HPB17-0176 1685 Collins Av
2/8/2022 meeting "Exhibit A"

Re: Objection to Application for Certificate of Appropriateness for the partial demolition, renovation and restoration of the existing building, including the reconstruction of original interior floor plates, modifications to the rear cabana building and site improvements for the property located at 1685 Collins Avenue, Miami Beach, Florida (Historic Preservation Board File No. 17-0176).

RE: 1685 Collins Avenue – Certificate of Appropriateness for partial demolition and renovation, hardship letter for variances (HPB17-0176)

Ⓢ SITE PLAN 1:50

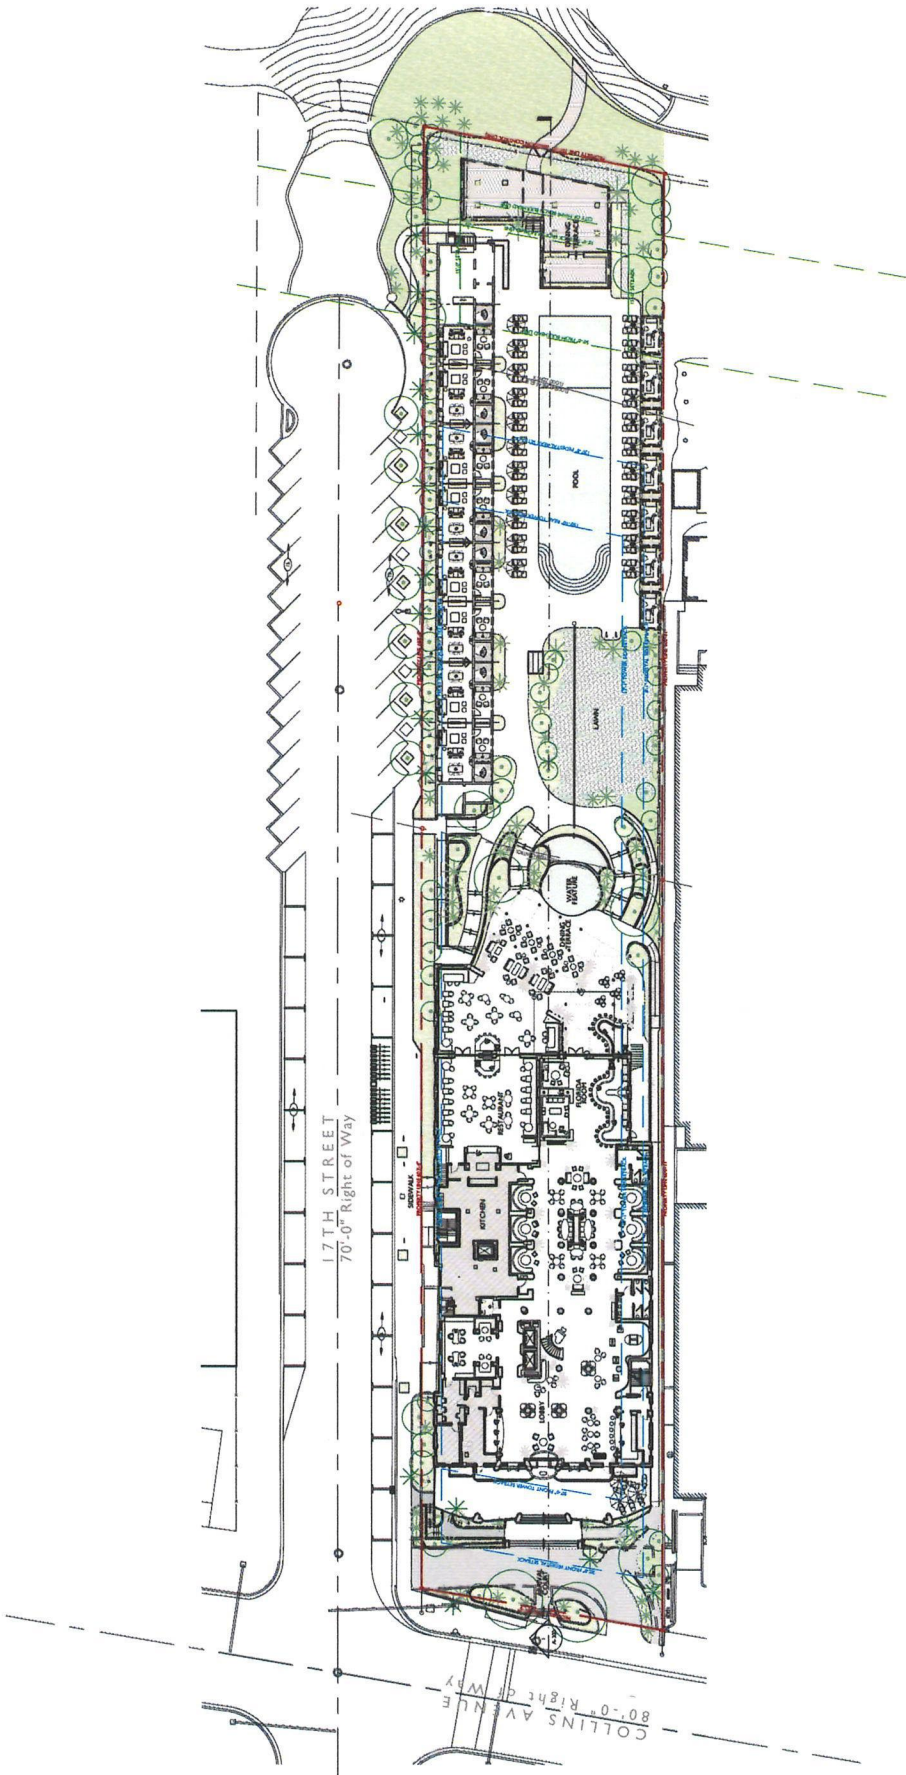
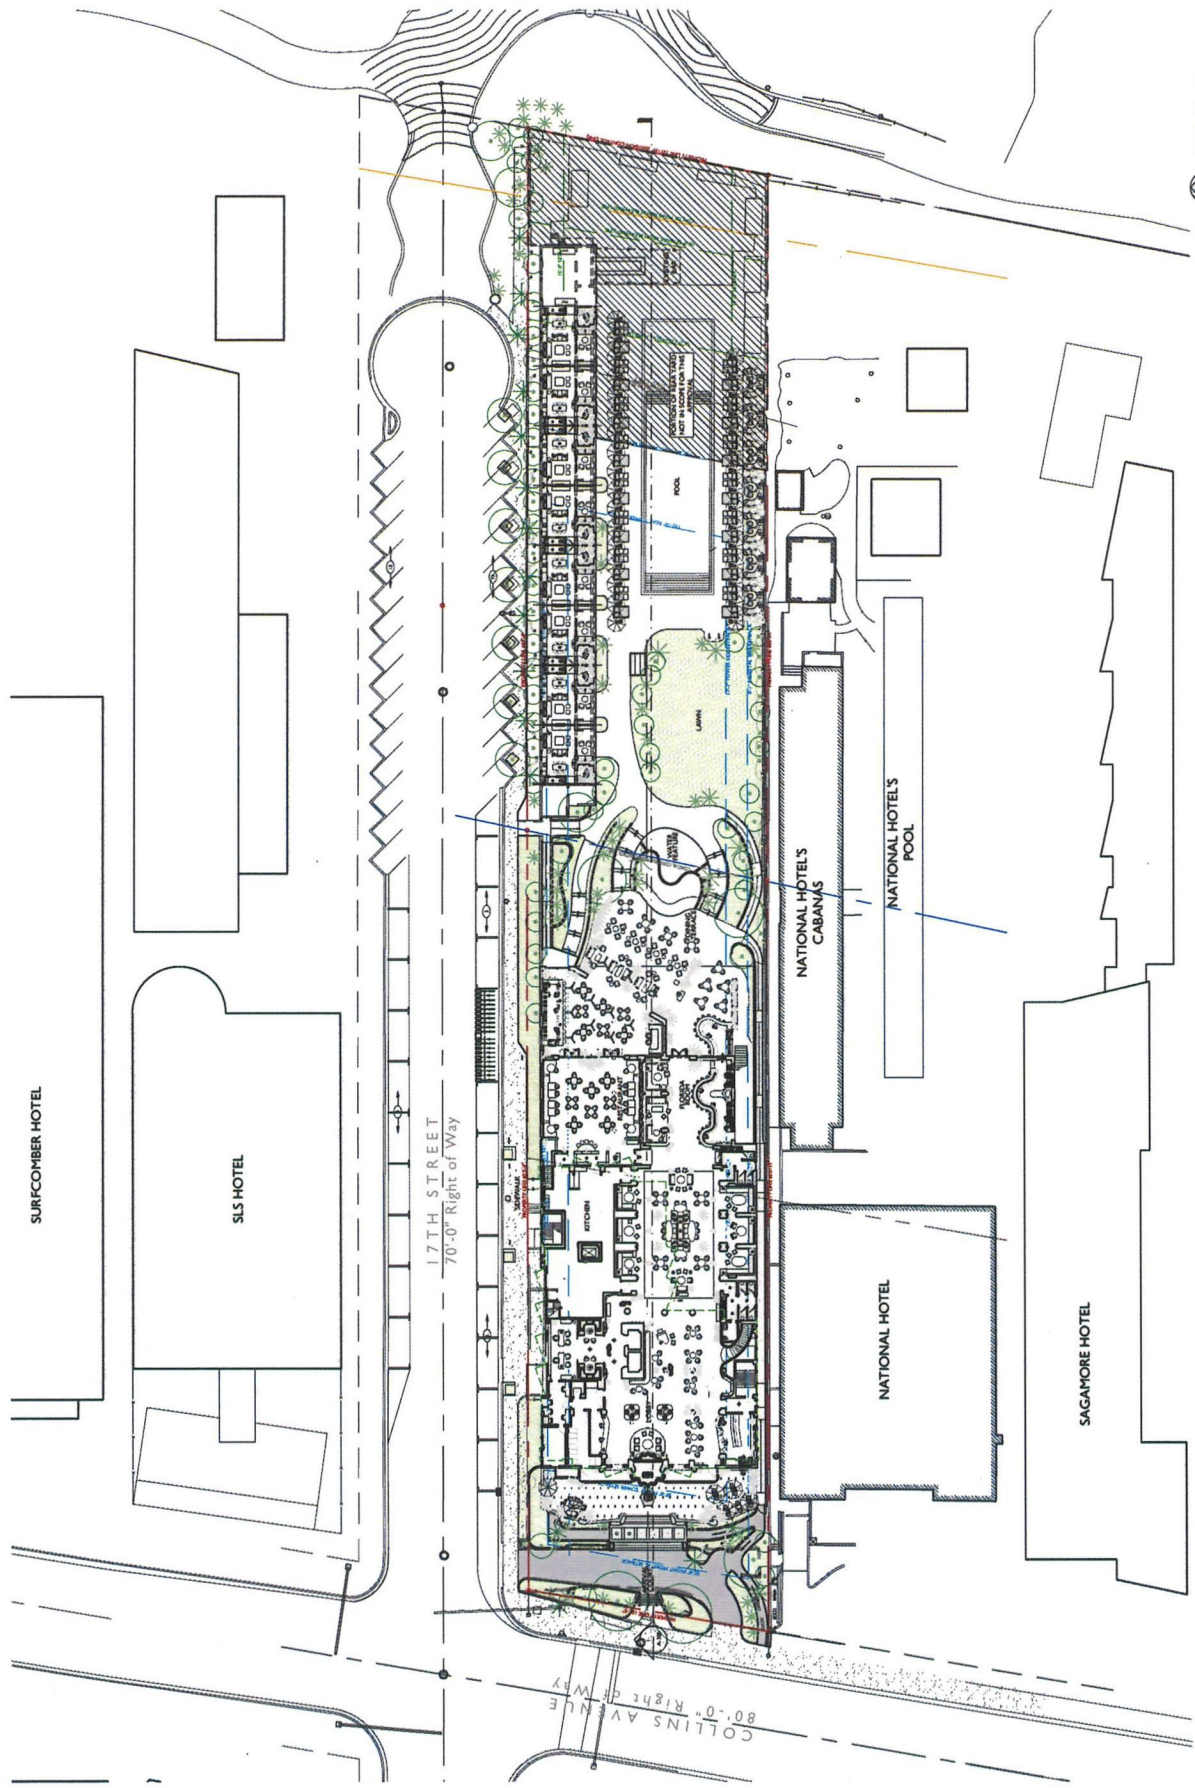
Further, to avoid scrutiny of the six zoning violations in the dune preservation overlay and the oceanfront bulkhead setback, open space and view corridors, the Applicant is trying to sever the rear half of the site from review by this Board by adding hash lines on a part of the latest Site Plan and providing the caveat "Portion of Rear Yard Not in Scope for this Approval." Compare copies of the original and current Applicant Site Plans, A2.00 attached hereto.

Removing a section of the Site Plan from HPB review is contrary to the application requirements for a Certificate of Appropriateness which requires a “complete site plan” for review. Indeed, the removal of those portions of the site plan is contrary to the application requirement for a Certificate of Appropriateness to have a “Complete Site Plan” for review. Should the site plan be incomplete, the Application cannot be reviewed for compliance with the review criteria and the Applicant is not authorized by the Code to unilaterally remove those critical sections from the Site Plan on its whim. Indeed, Sheets A.1.02C and A 1.03B of the plans before the Board demonstrate that the Applicant intends to demolish structures and hardscape in the same area on which the Applicant drew its hash marks on the current Site Plan and in that same area that Applicant unilaterally contends to be in the “Portion of the Rear Yard Not in the Scope for this Approval.” See Site Plan A.2.00.
